## ADDENDUM NO.2

### PROJECT – ECA @ CEC Modernization, Renovation & Addition

RFP NO. 21-032 RRR  
APS PROJECT # 507  
NIGP Code: 90927; 90928; 909

P-401  
ADDENDUM No. 2  
EXHIBIT 02

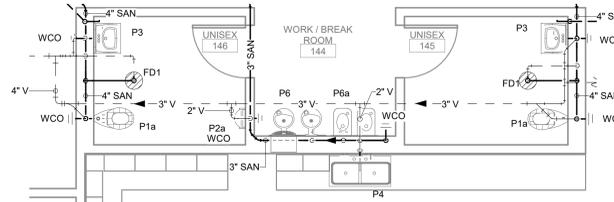
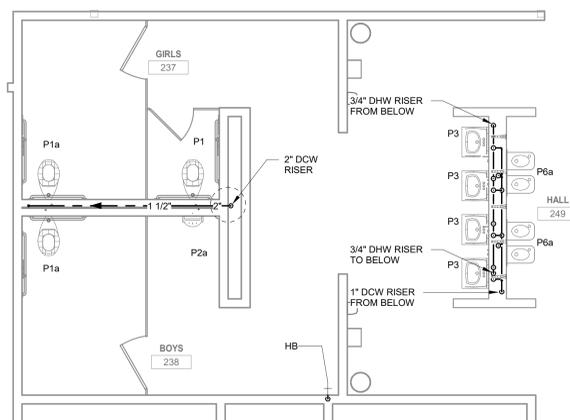
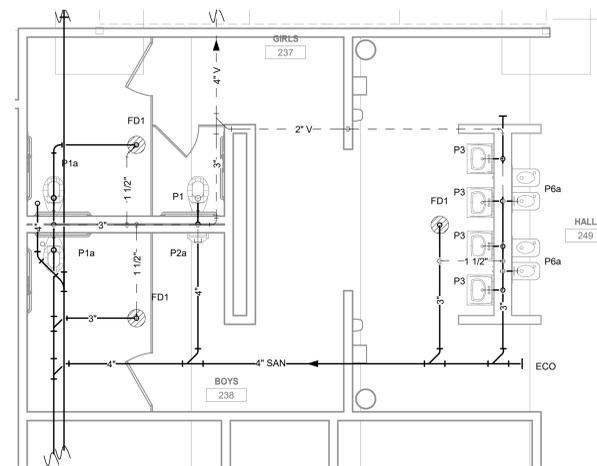
- a. ADD Floor drains to Unisex 145 and Unisex 146
- b. CHANGE Sanitary routing in Girls 237. Refer to the revised sheet, see **Exhibit 02**.

ADDENDUM No. 2  
EXHIBIT 03

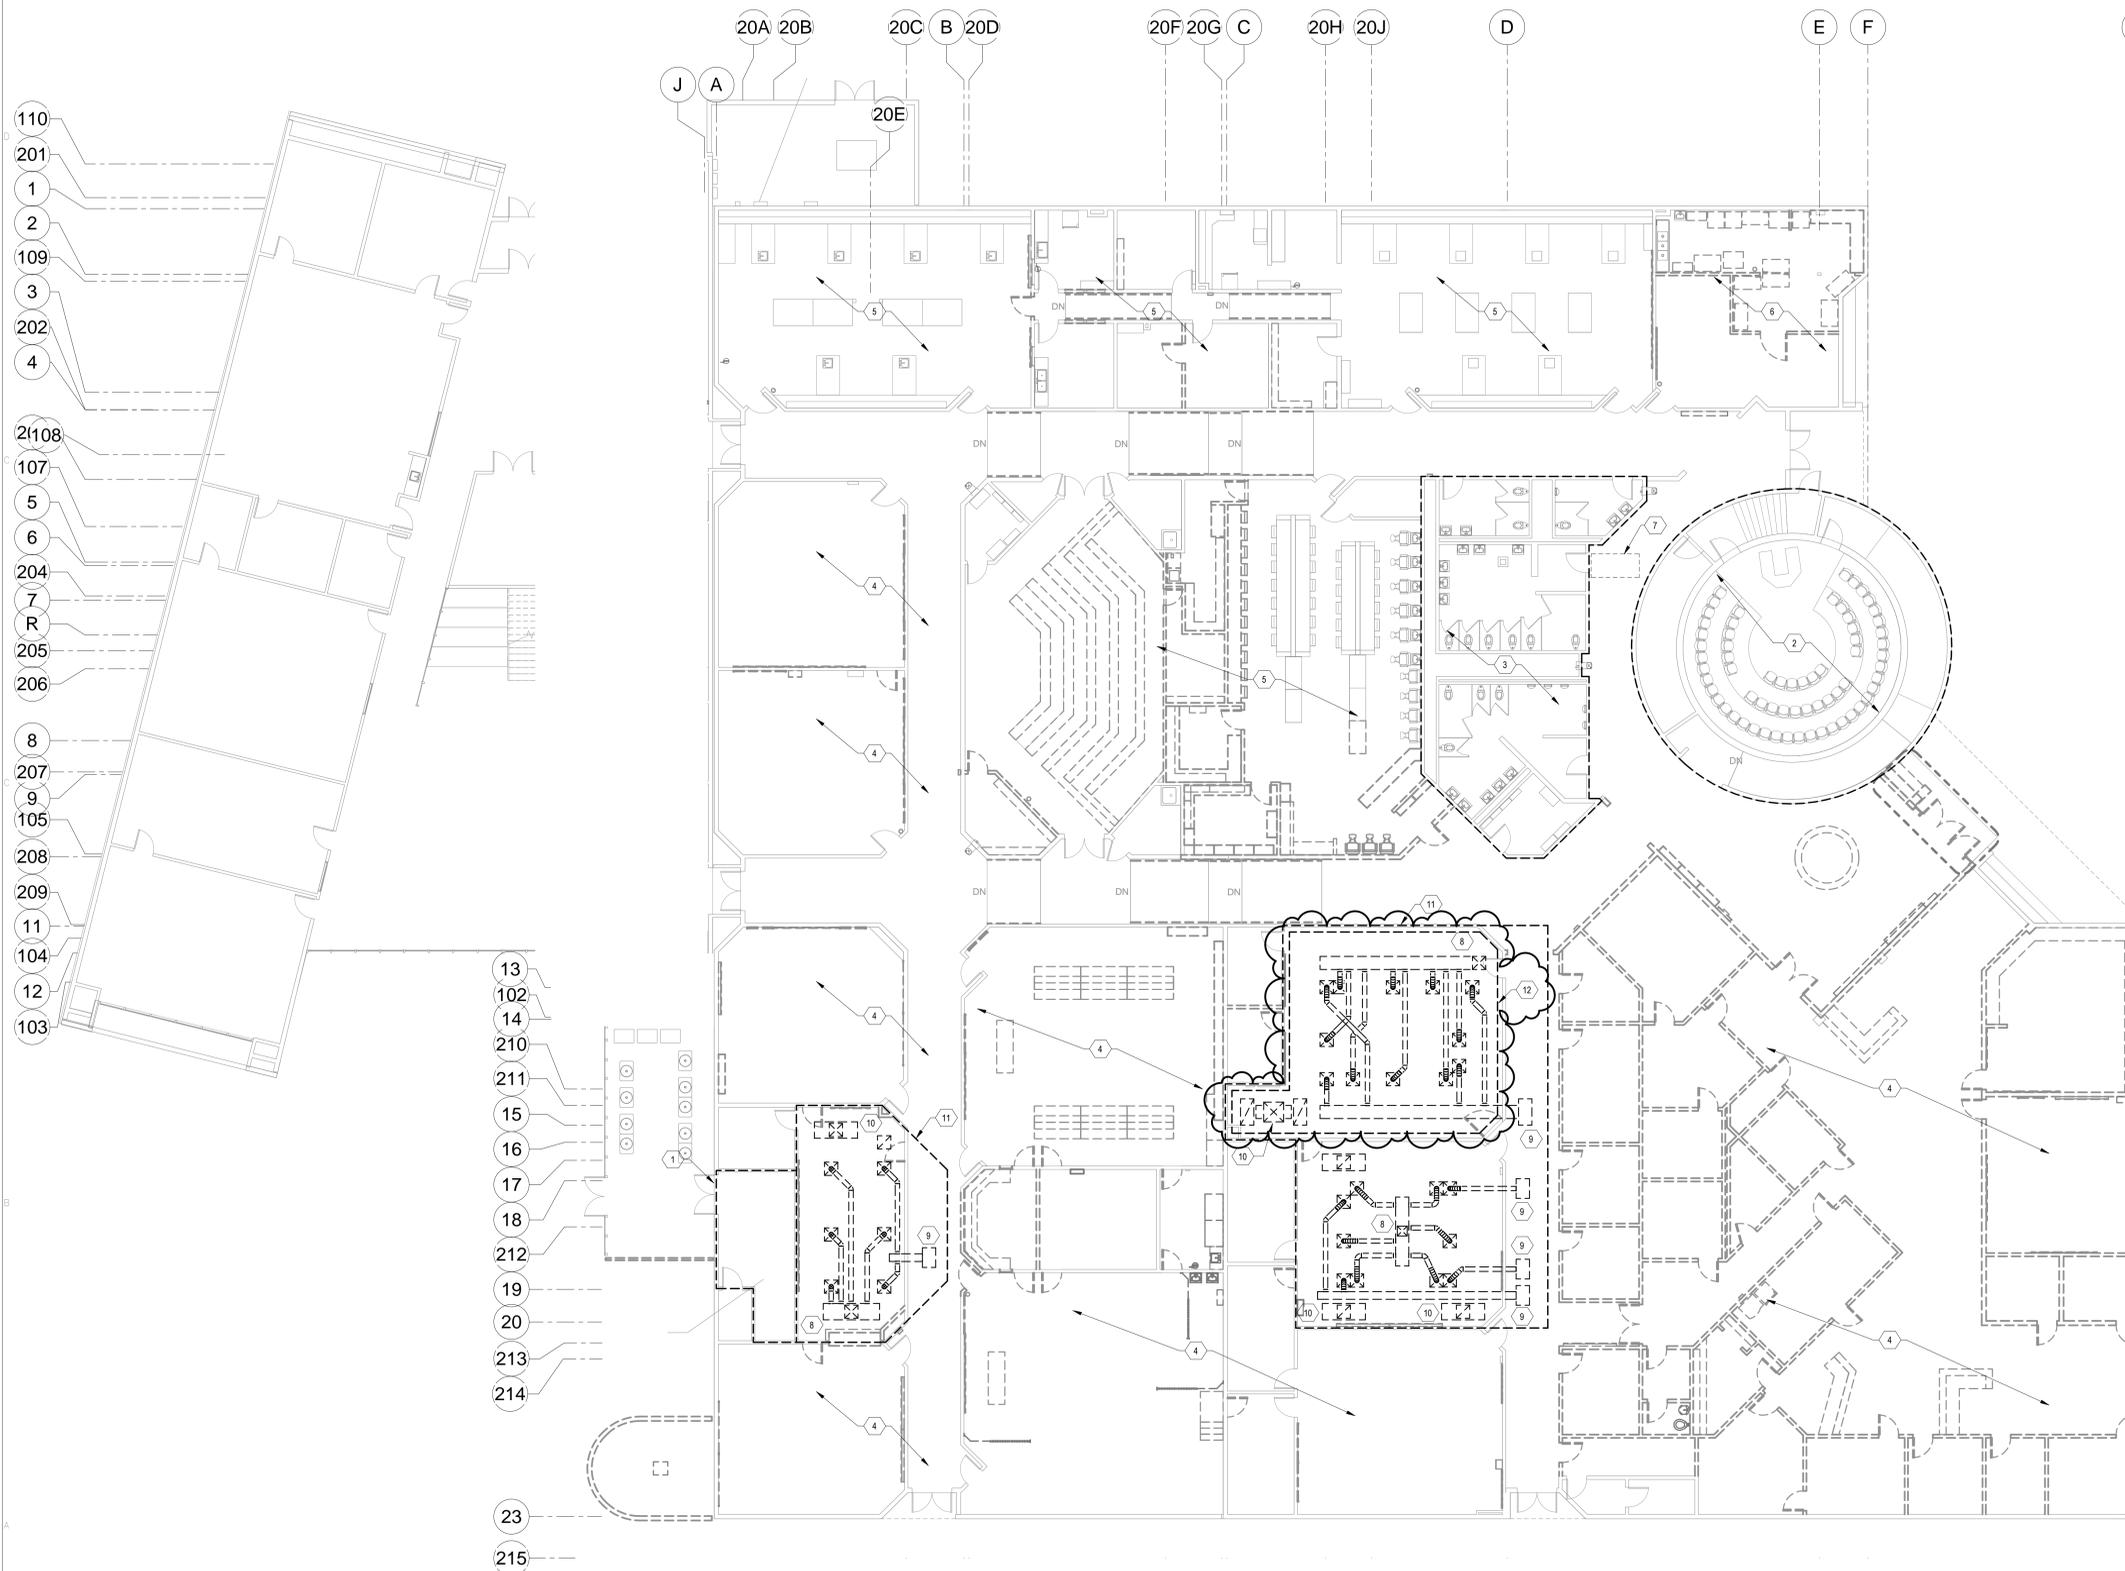
- a. ADD keynote #12 indicating the removal of floor supply diffusers from Computer Classroom. Refer to the revised sheet, see **Exhibit 03**.

12. REMOVE APPROXIMATELY THIRTY FLOOR SUPPLY GRILLES IN CLASSROOM. COORDINATE FLOOR PATCHING WITH GENERAL CONTRACTOR.

MH101  
ADDENDUM No. 2  
EXHIBIT 04

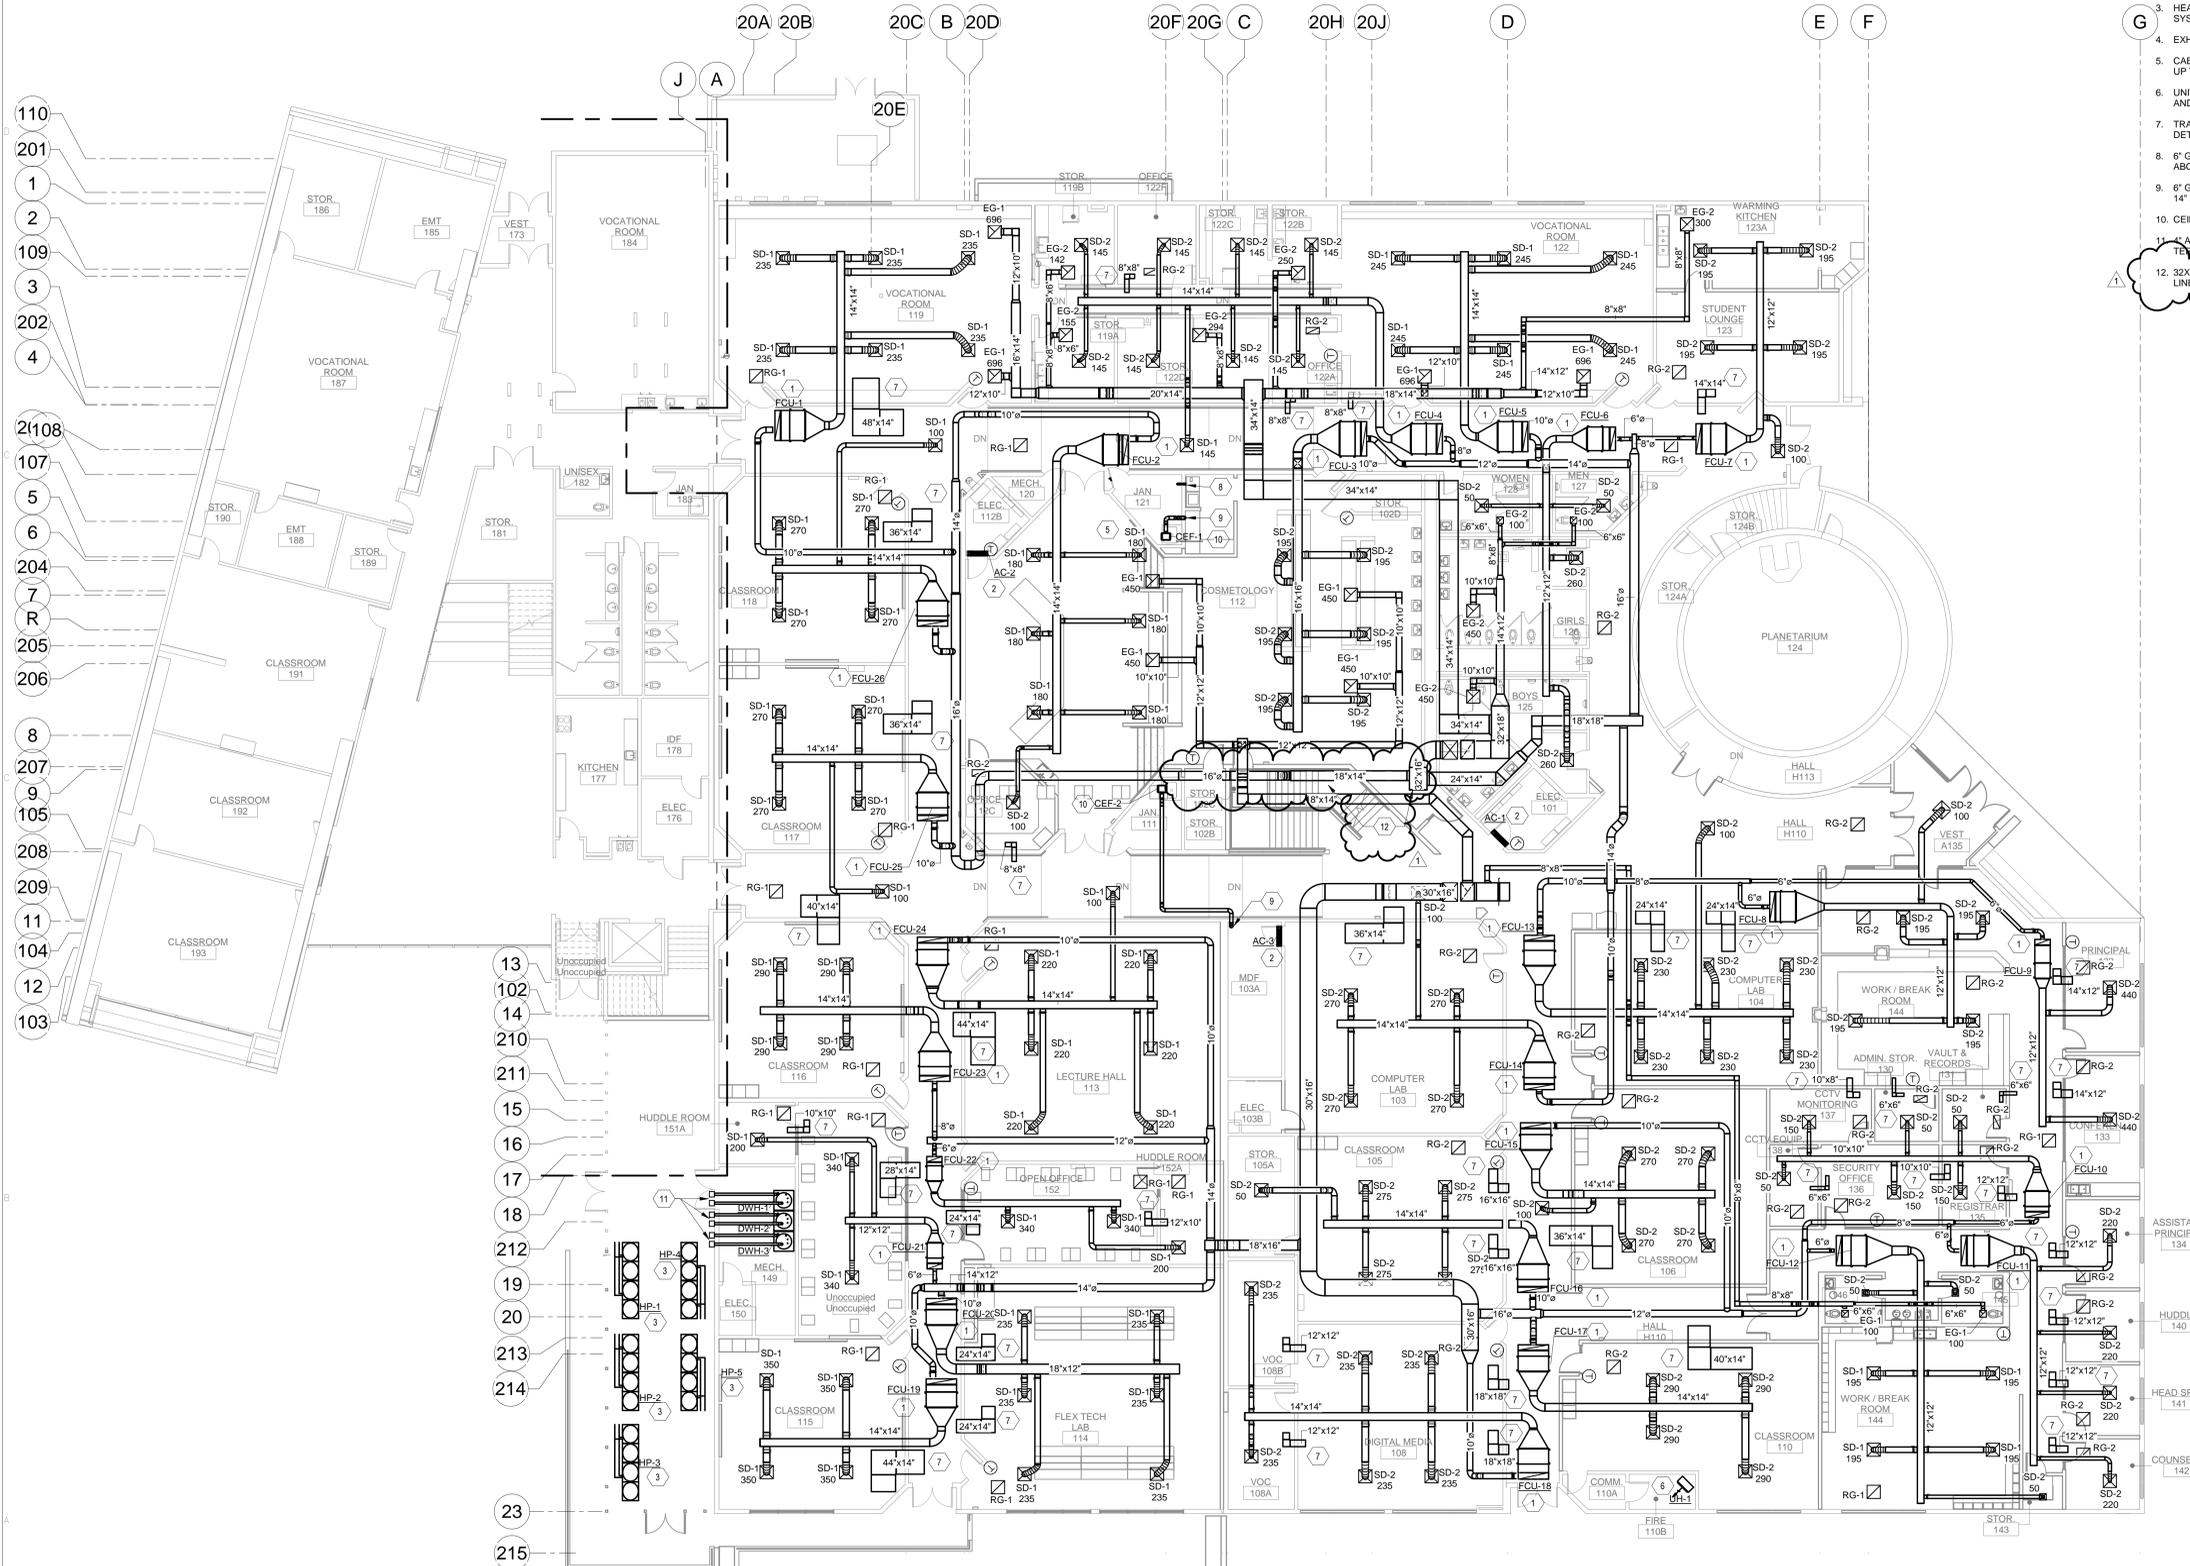
- a. ADD – keynote #12 indicating the addition of acoustic liner is the ERV duct work. Duct work sizing and routing has also been updated. Refer to the revised sheet, see **Exhibit 04**.

- 11. 4" GALVANIZED EXHAUST DUCT TO WATER HEATER. TERMINATE AS SHOWN WITH WATERCAP.
- 12. 32X16 DUCT MAIN AND 18X14 VENTILATION DUCT SHALL HAVE 1" ACOUSTIC LINER.

EL102  
ADDENDUM No. 2  
EXHIBIT 05

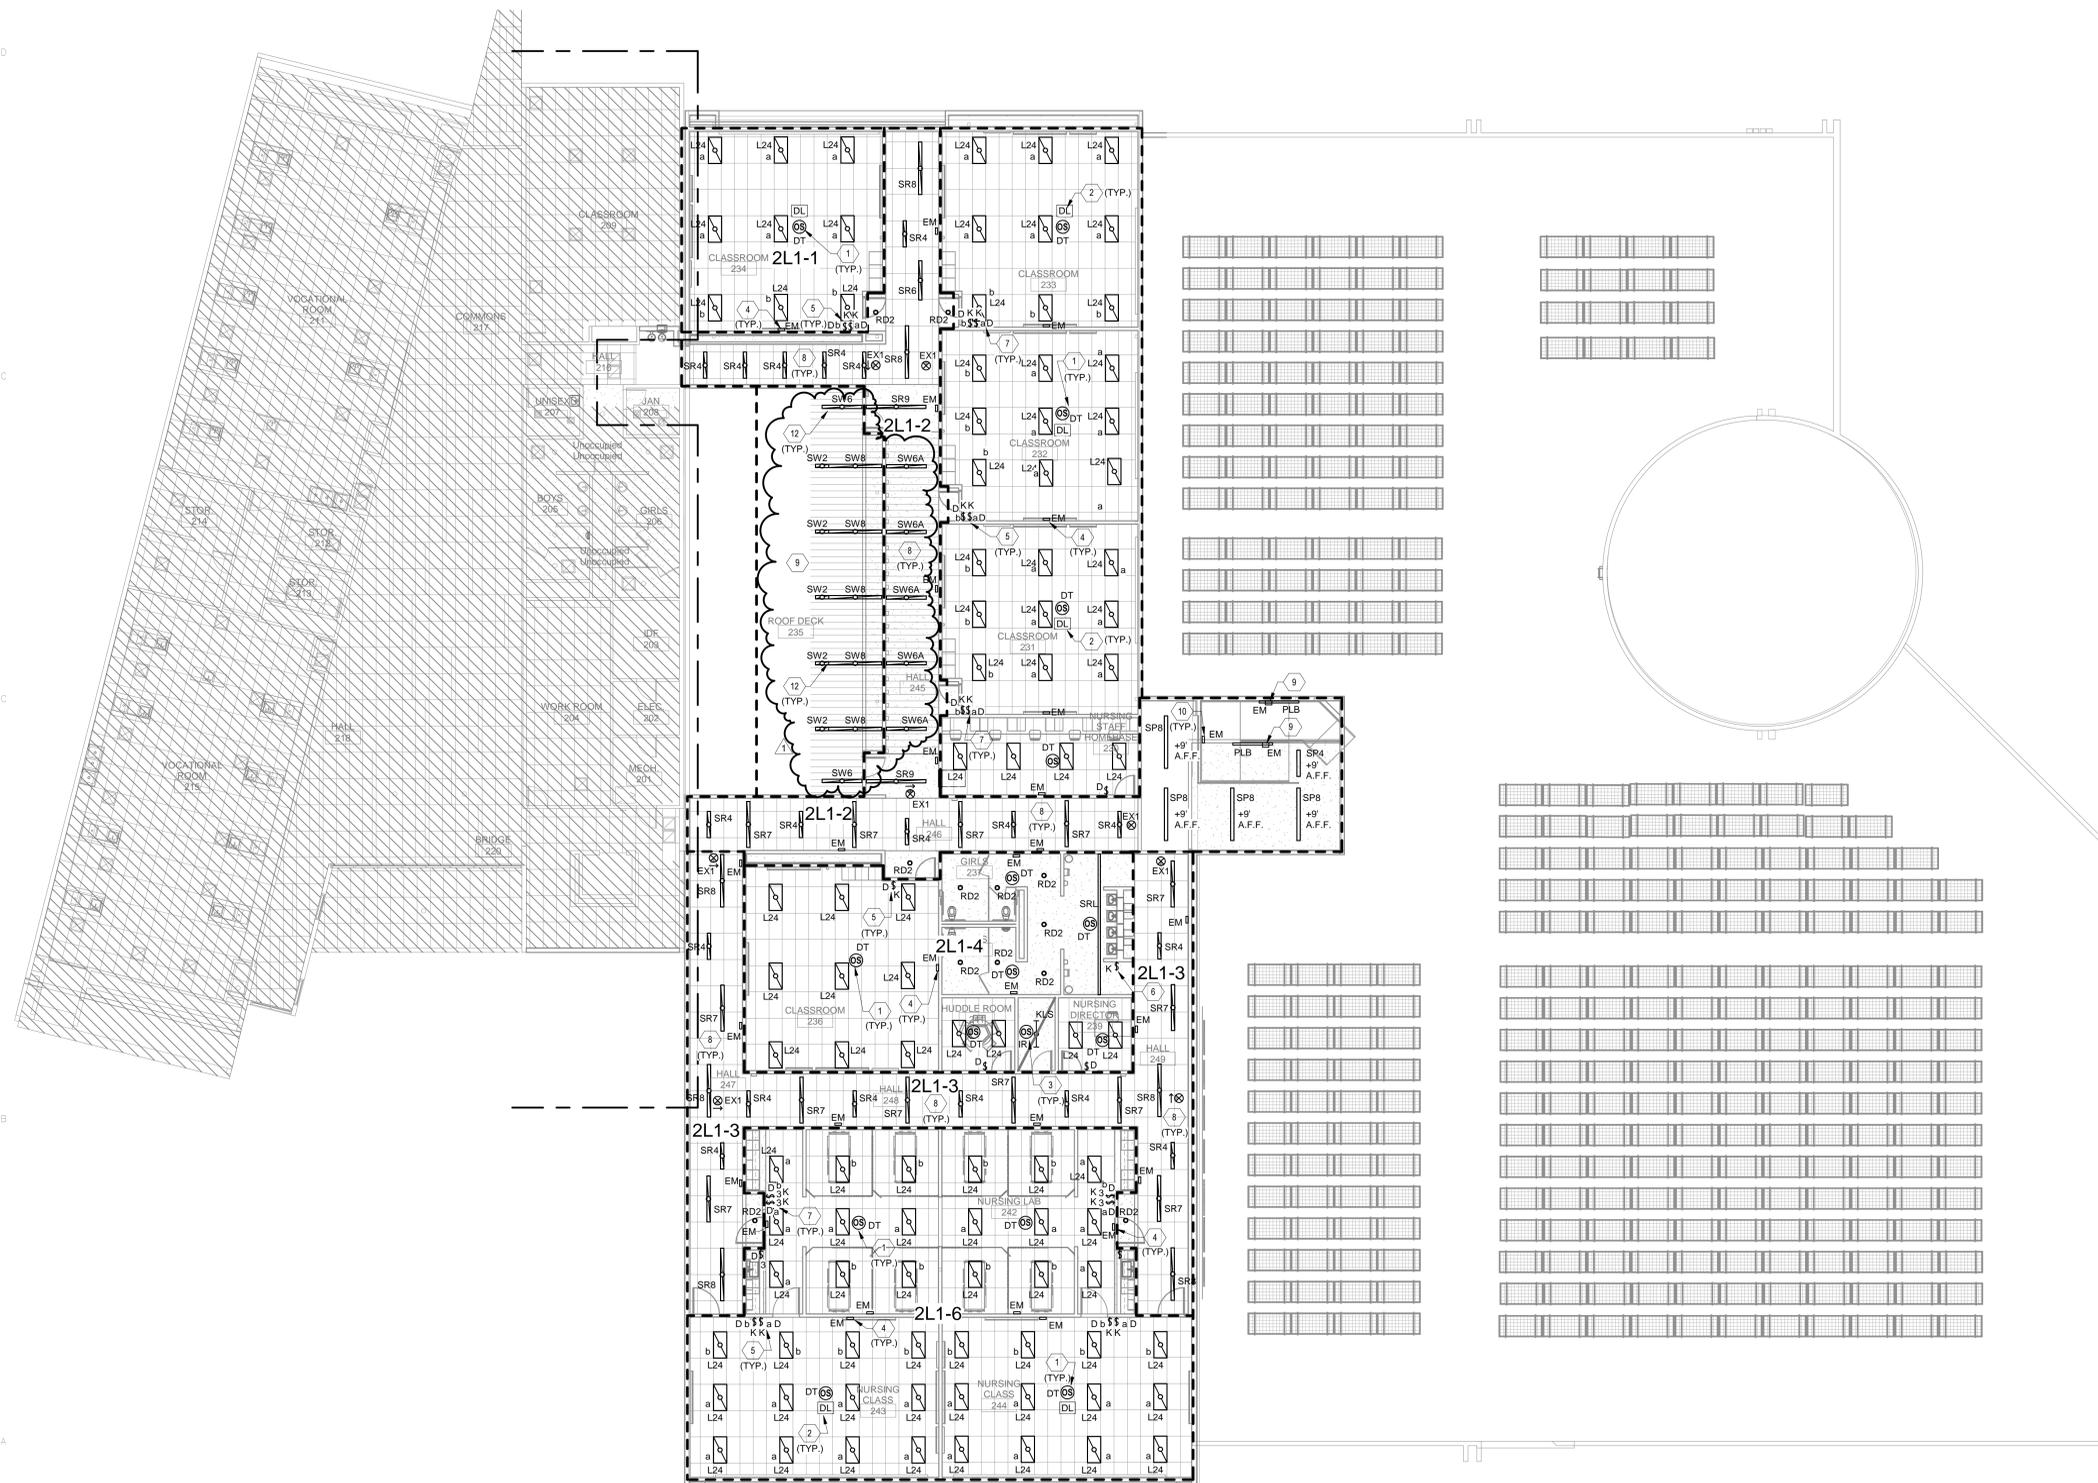
- a. CHANGE (5) SR6, (7) SW2, AND (12) SW4 lighting fixtures per revised drawing, see **Exhibit 05**.
